APPENDIX D

Consultation Record

Project Title	Pear Tree Solar Farm
---------------	----------------------

Meeting Title	Hydraulic Modelling Discussion
---------------	--------------------------------

Figure 1: Locations on the River Hull which intersect the red line boundary for the site where breaches are not proposed.

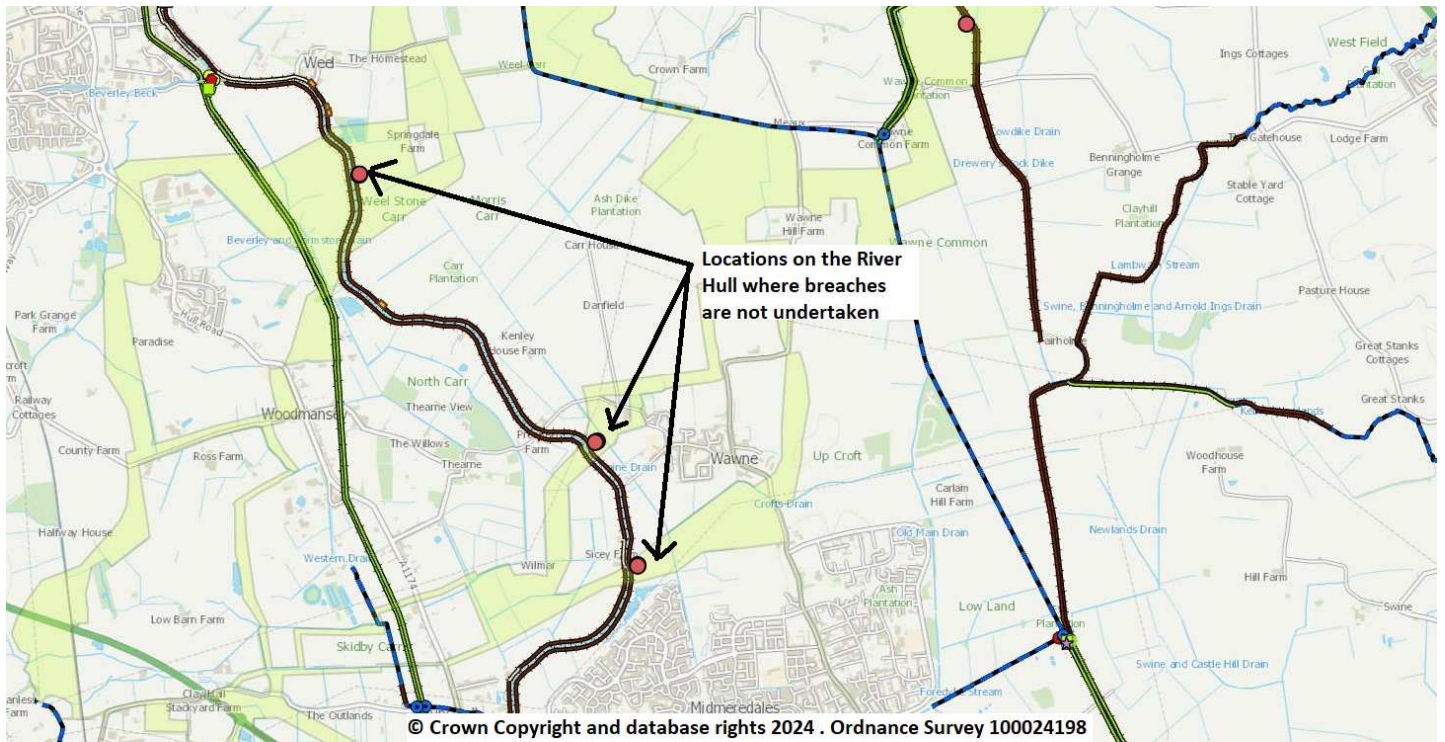
What was the rationale for not undertaking a breach at east 506700 north 438725, east 508280 north 436920, and east 508565 north 436090 on the left and right bank of the River Hull (figure 1 below)? Is this because these are relatively low risk areas for cable routing?
